Washington Public Power Supply System

Docket No. 50-508

Subject: NUCLEAR PROJECT 3
RESPONSES TO NRC SAFETY
EVALUATION QUESTIONS

POTENTIALLY RADIOACTIVE GASEOUS
EFFLUENT RELEASE POINTS

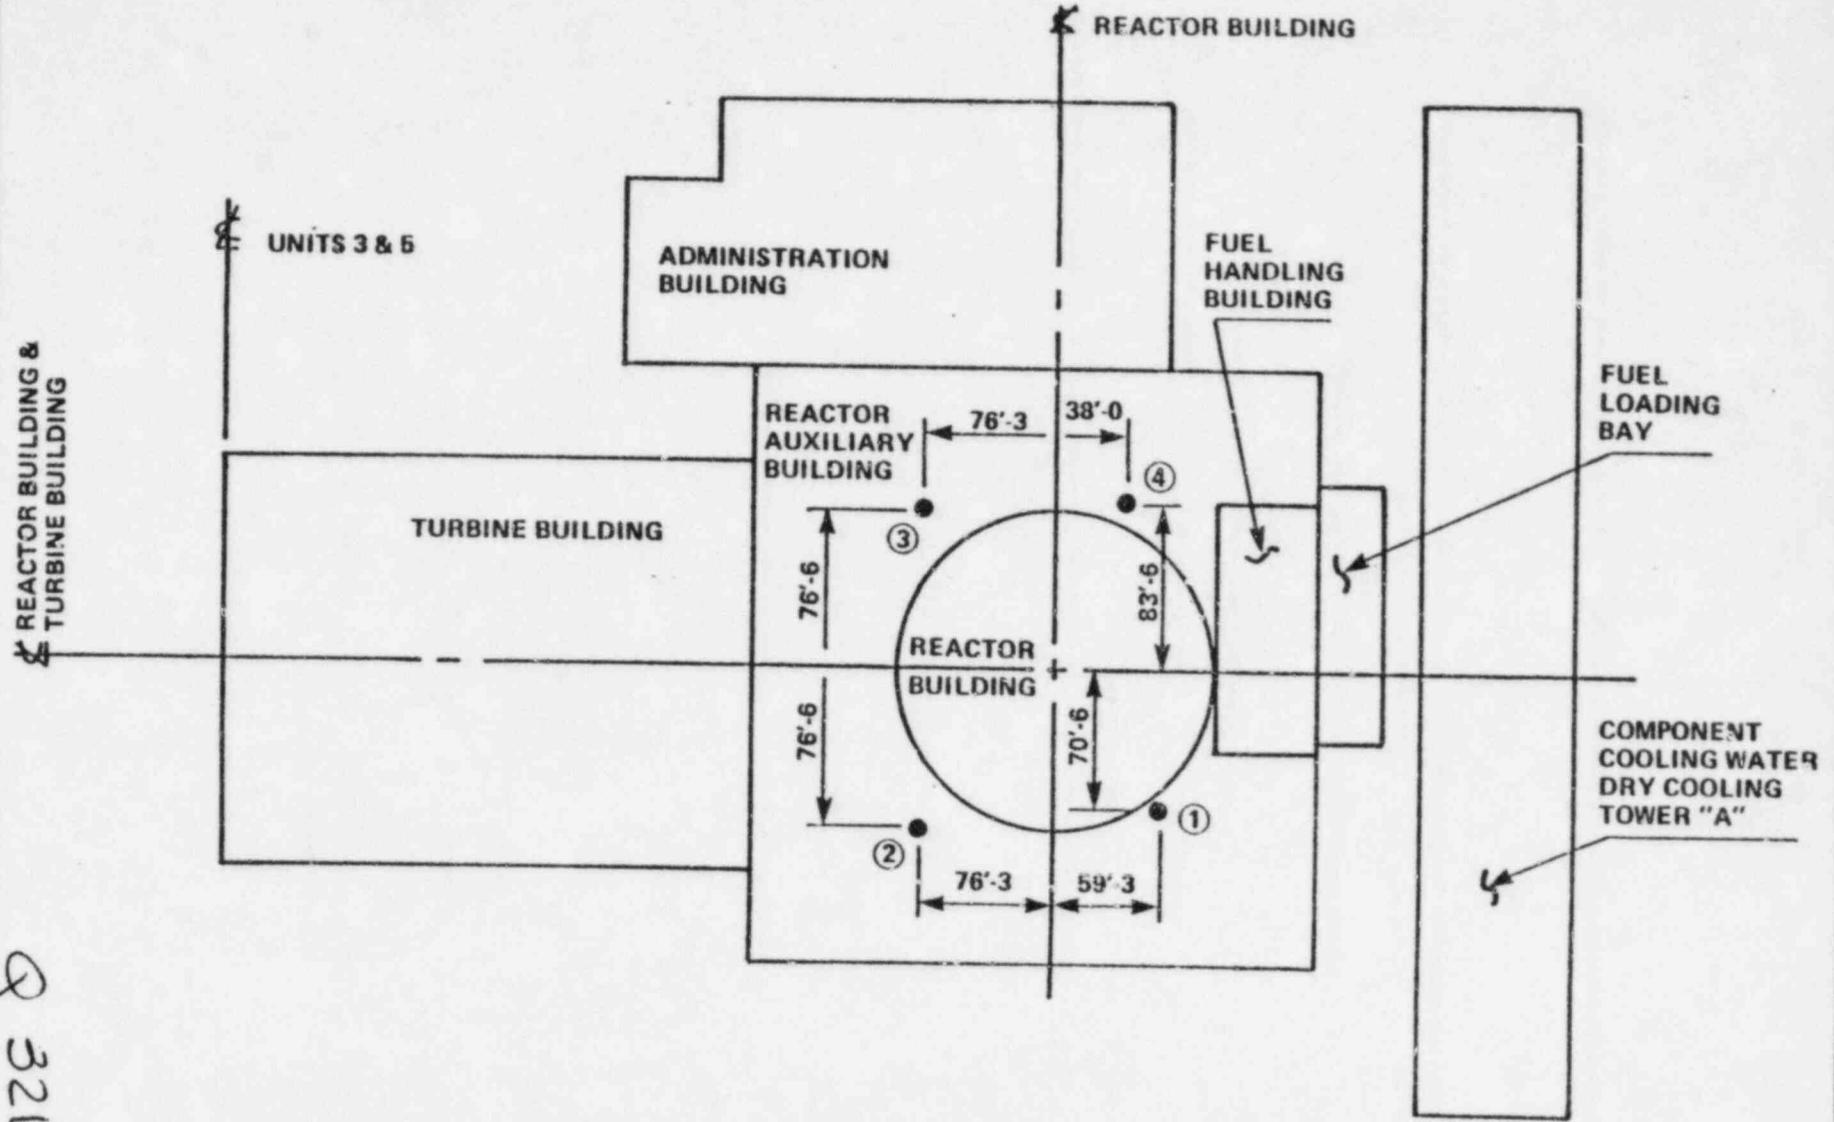
There are several discrepancies in the descriptions of radioactive gaseous effluent release points between the text, tables and figures in the Environmental Report and the Safety Analysis Report. For example, Table 3.5-8 (ER) identifies six release points, referencing ER Figure 3.5-8 as a pictorial guide. In the FSAR, the six release points are designated "HVAC Vent Stacks #1 through #6," while Table 3.5-8 (ER) gives such titles as "Fuel Handling Building Vent." Figure 3.5-8 and Figure 1.2-15a (FSAR) show discrepancies in stack height; for example, Vent Stack #4 on Figure 1.2-15a is shown to be 485 feet above mean sea level (msl) while Figure 3.5-8 (ER) shows the same vent at 502.8 feet above msl. No release point is shown for the effluent from the main condenser air ejector during normal operation -- only the alternate is shown for use during periods of known radioactive release. For all radioactive effluent release points, please provide corrected and consistent tables, diagrams and text showing location, designation or title, release point elevation, shape and inside dimensions of release point cross section, average effluent temperature and either exit velocity or volumetric flow rate. The requested data is needed to adequately assess the meteorological dispersion conditions attending gaseous effluent releases.

Figure 3.5-8 of the Environmental Report identifies the location of the radiological and toxic release points for WNP-3. The radiological release points have been extracted and shown in Figure 1 (attached). Table 1 (also attached) indicates the designation, elevation, inside diameter, flow rate and temperature of each release point, as well as the various systems/components exhausted.

FIG. 10.3-1

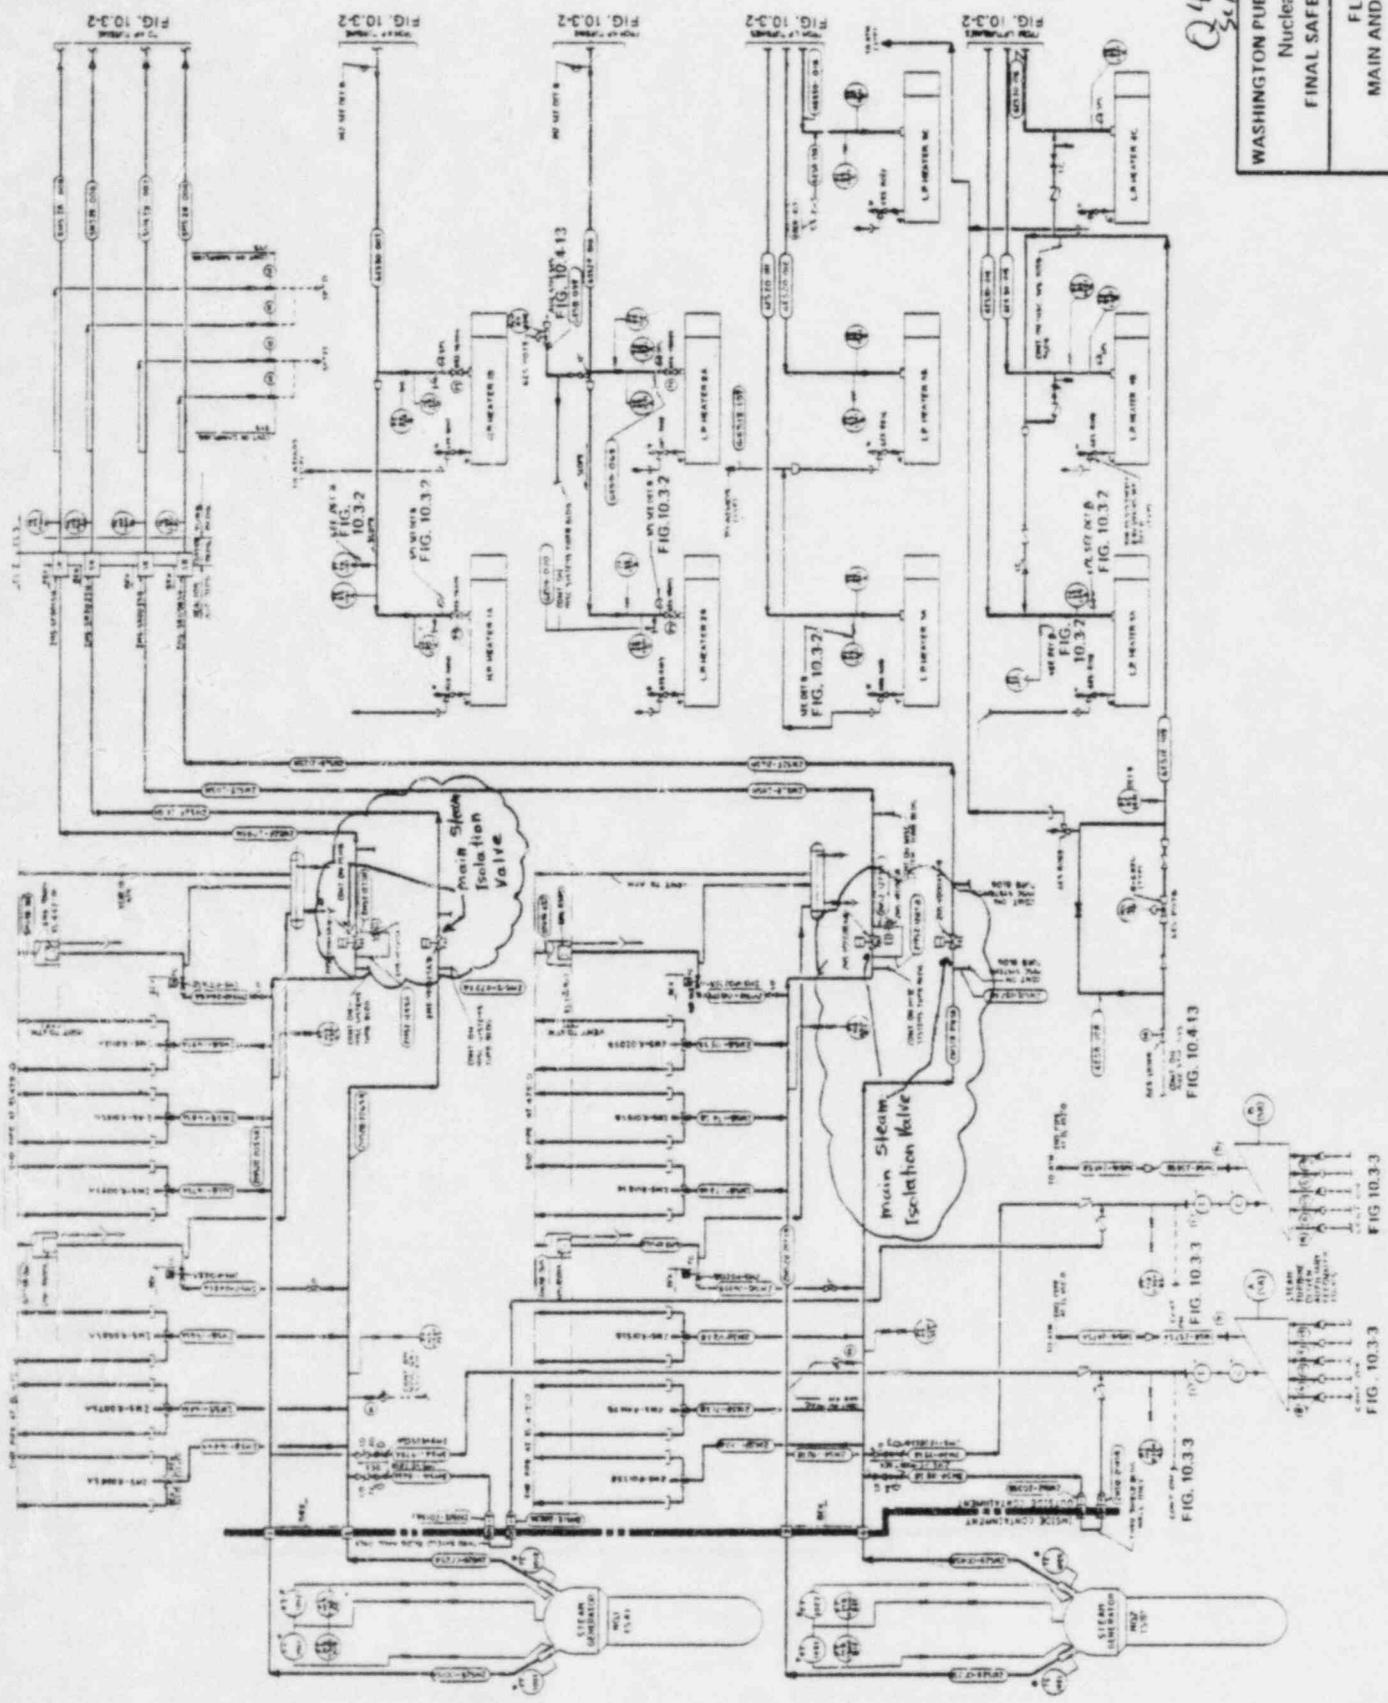
410.47 Identify Main Steam Isolation Valves (MSIV's) on Figure 10.3-1.
(10.3) In order to prevent blowdown of more than one steam generator, verify that the Main Steam Isolation Valves are designed to stop full main steam flow at the maximum design differential pressure in both directions in the event of a main steam line break in one steam line upstream of an MSIV and corresponding single failure (to close) in an MSIV to the other steam generator.

FSAR Figure 10.3-1 will be amended to identify the Main Steam Isolation Valves and FSAR Subsection 10.3.2.2.2 will be amended to reflect the above response.

EMERGENCY DIESEL GENERATOR LUBE OIL MAKE-UP SYSTEM

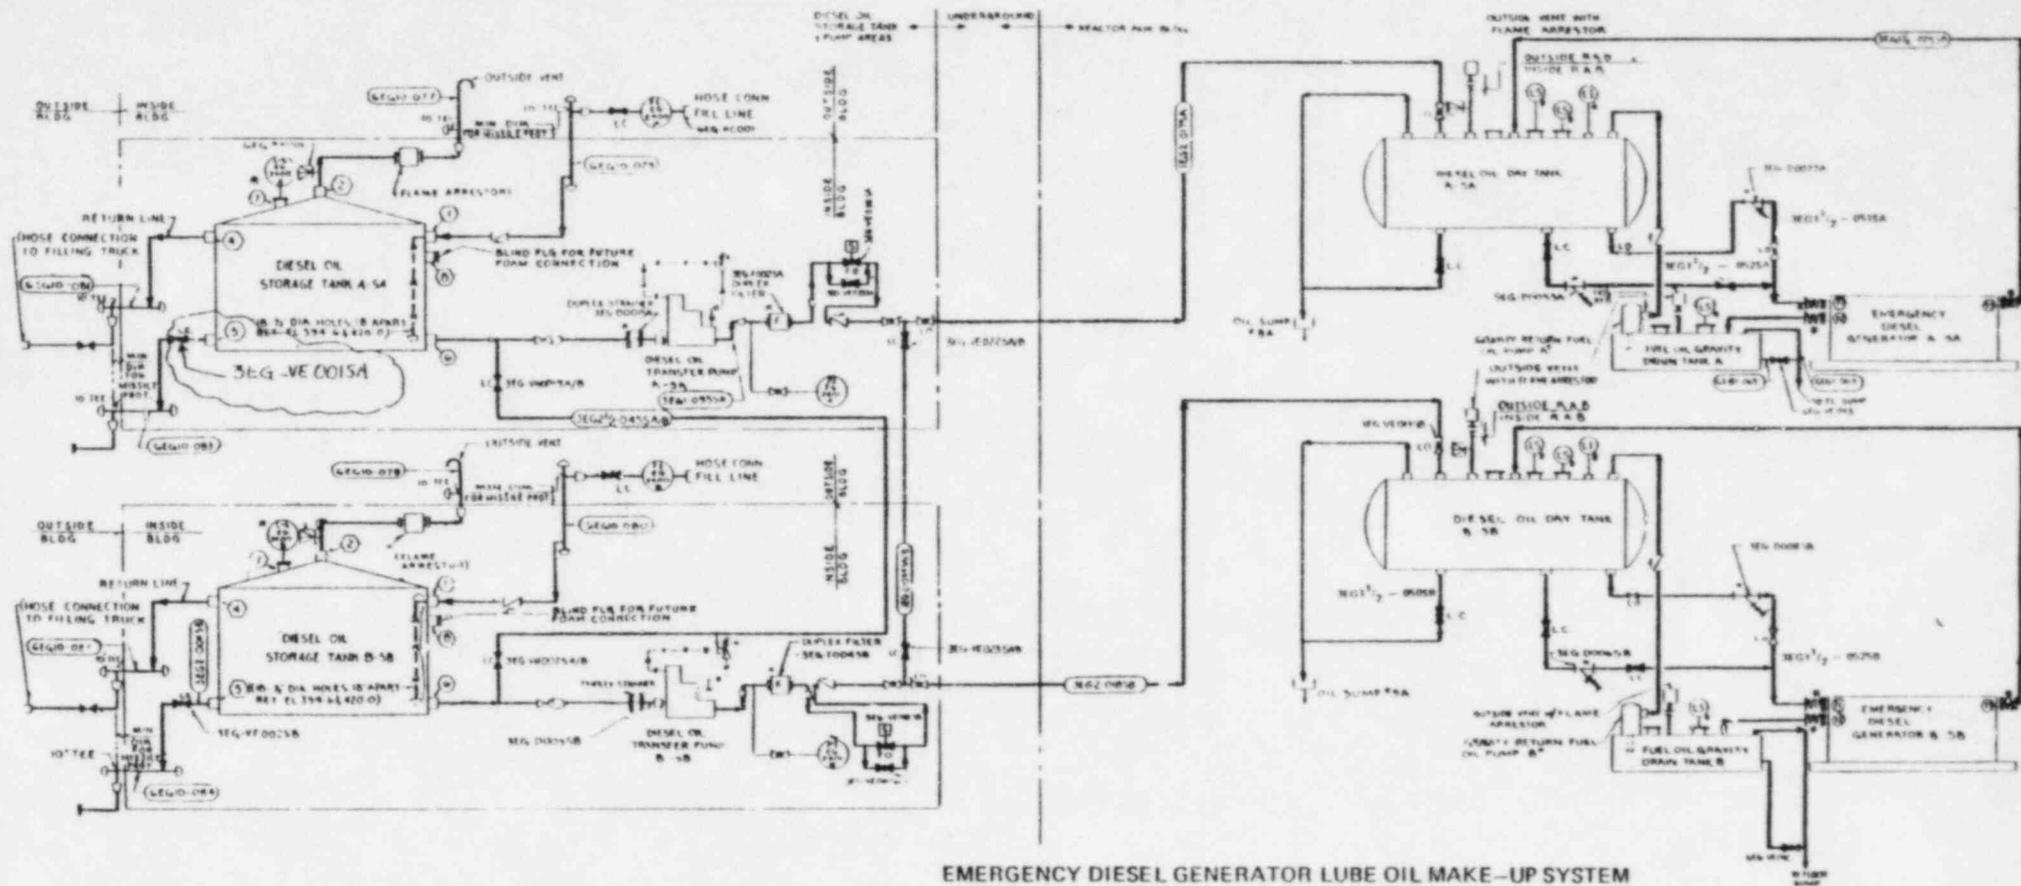
430.13 Refer to FSAR Figure 9.5.4-1. What is the purpose of the valve
(9.5.4) 3 EG-VE002SB and line 6EG10-084 on storage tank B-SB, as well as
similar lines on storage tank A-SA? Also, provide a table
explaining the legends and note references on Figure 9.5.4-1.

Valves 3 EG-VE001 SA and 3 EG-VE002SB are used to drain the Diesel Oil Storage Tanks. The subject normally closed (locked closed) drain valves and their associated drain lines between the valves and the Diesel Oil Storage Tanks, are designed to ASME Section III, Class 3 requirements to maintain the integrity of the tanks.

Lines 6EG10-083 and 6EG10-084 are part of the Diesel Oil Storage Tank drain lines which penetrate the Diesel Oil Storage Tank room wall to facilitate tank drainage from the outside. (These lines, located directly in front of the penetration, are fabricated a ten inch tee with one inch wall thickness and act as missile barriers to provide protection for the safety related equipment located within the seismic Category I Diesel Oil Storage Tank room.) For further clarification, refer to the response to Question 430.12.

Figure 1.7.2-1 provides the legend used in the Diesel Generator Fuel Oil Storage and Transfer System Figure 9.5.4-1. FSAR Figure 9.5.4-1 will be amended to reflect the response to this question.

INSERT A

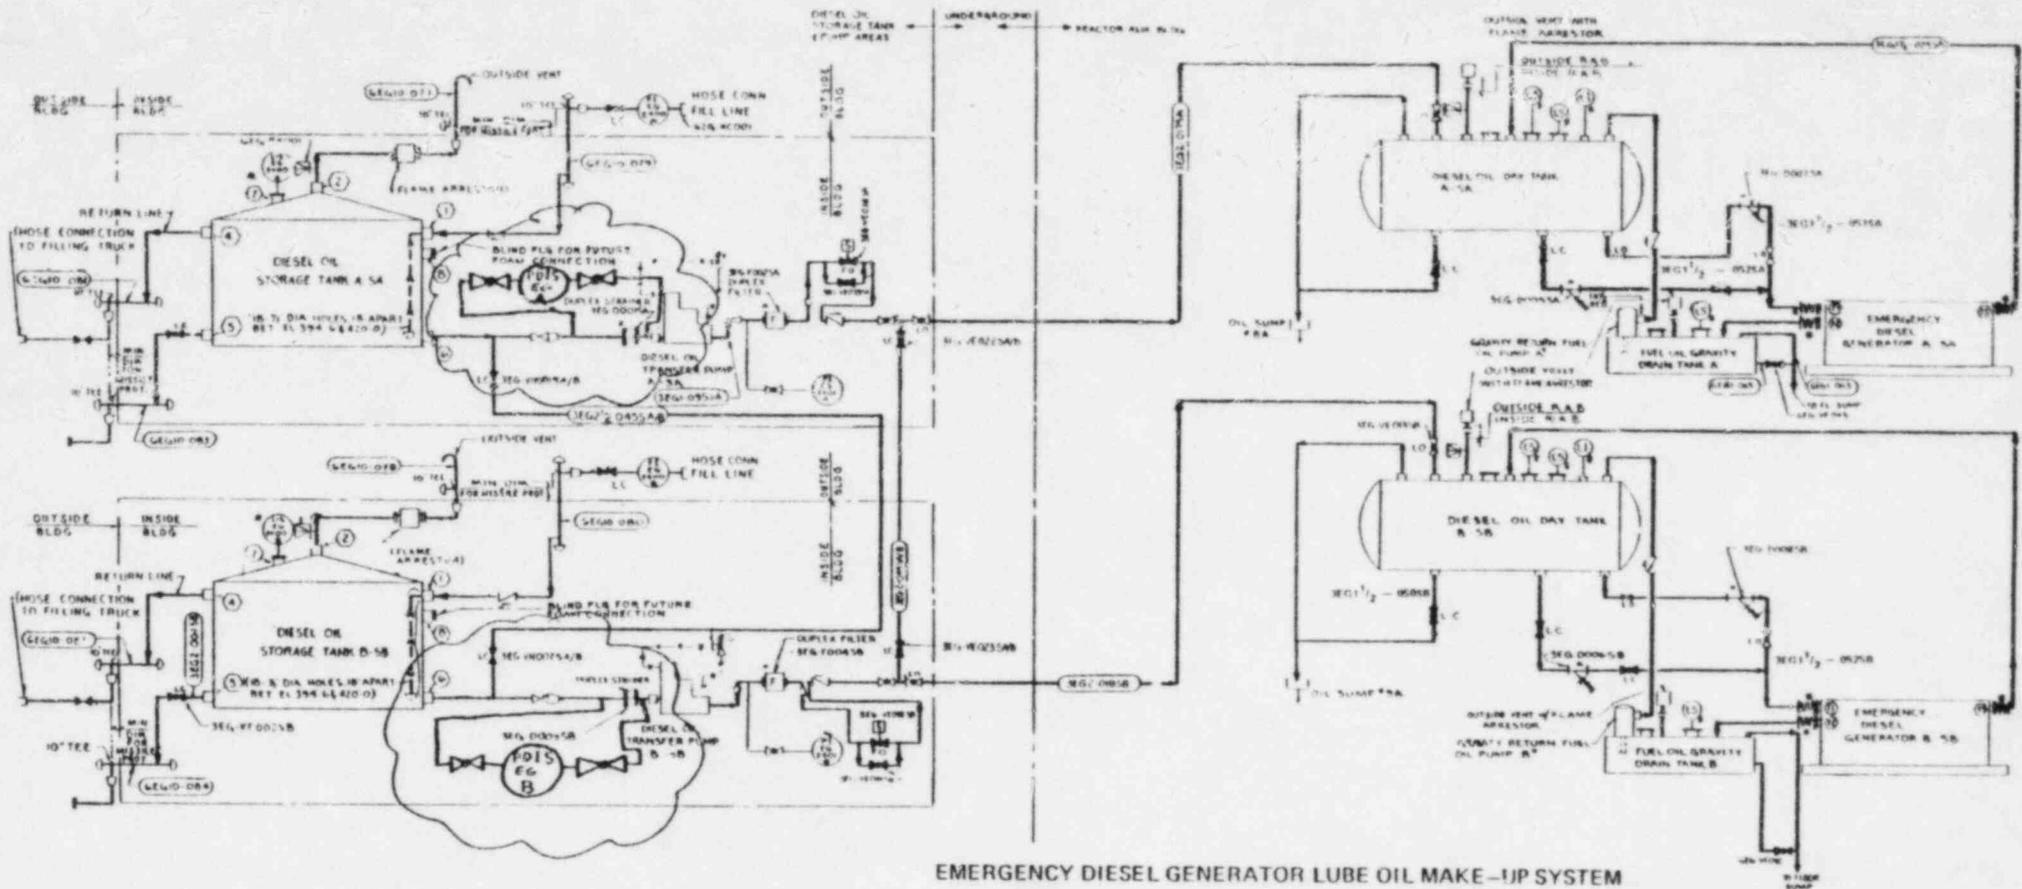
430.15
(SRP
9.5.4) Regulatory Guide 1.137 (by reference to ANSI N195) requires that duplex fuel oil strainers and filters be fitted with differential pressure indicators and alarms. This instrumentation is not discussed in the FSAR, nor is it shown on Fig. 9.5.4-1. Revise your FSAR to include this instrumentation, or provide justification for not having same. Show instrumentation and control on Fig. 9.5.4-1.

FSAR Subsection 9.5.4.2.2 and Figure 9.5.4-1 will be revised to include differential pressure indicating switches across the duplex fuel oil strainers. The differential pressure indicating switches will alarm logically in their respective Diesel Generator Room and in the Main Control Room via a common trouble alarm. ANSI N195 does not require fuel filter differential pressure indicating switches.

Each duplex strainer is provided with a pressure differential indicating switch (PDIS) which alarms locally in its respective diesel generator room and in the main control room via a common trouble alarm to alert control room operators of a potentially clogged strainer.

<p>WASHINGTON PUBLIC POWER SUPPLY SYSTEM</p> <p>Nuclear Projects 3 & 5 FINAL SAFETY ANALYSIS REPORT</p>	<p>SBVS FAN FLOW CHARACTERISTICS VERSUS ANNULUS Δp</p>	<p>FIGURE 6 2-35a</p>
---	---	---------------------------

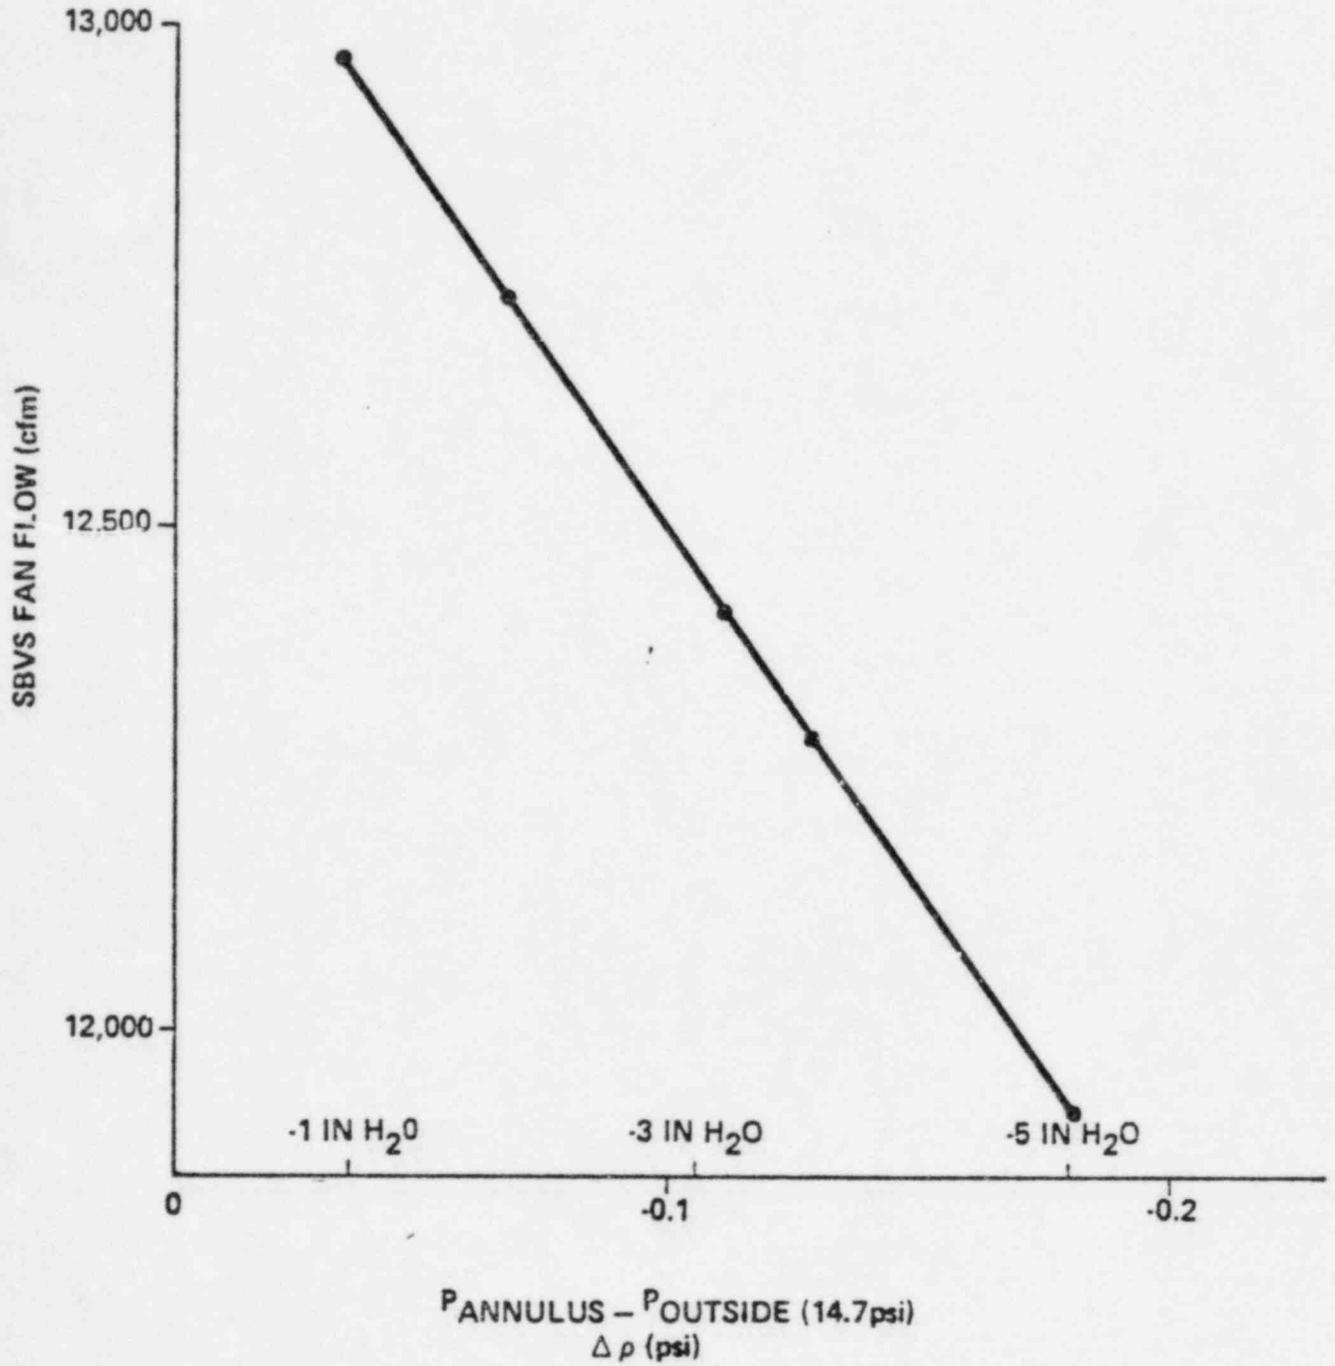
- b. The fan curve on Figure 6.2-35 shows that for a static pressure greater than 28 inches W.G., there exist two possible CFM values. Explain how the code input table was developed to obtain a proper CFM value.

Under accident conditions the fan will be operating at a CFM range as shown on Figure 6.2-35a extracted from the WATEMPT computer code utilized for the transient analysis. Therefore, in the event of a LOCA the fan can draw only one possible air flow at one specific static pressure value. FSAR Subsection 6.2.3.3.1 will be amended to clarify the above concern.
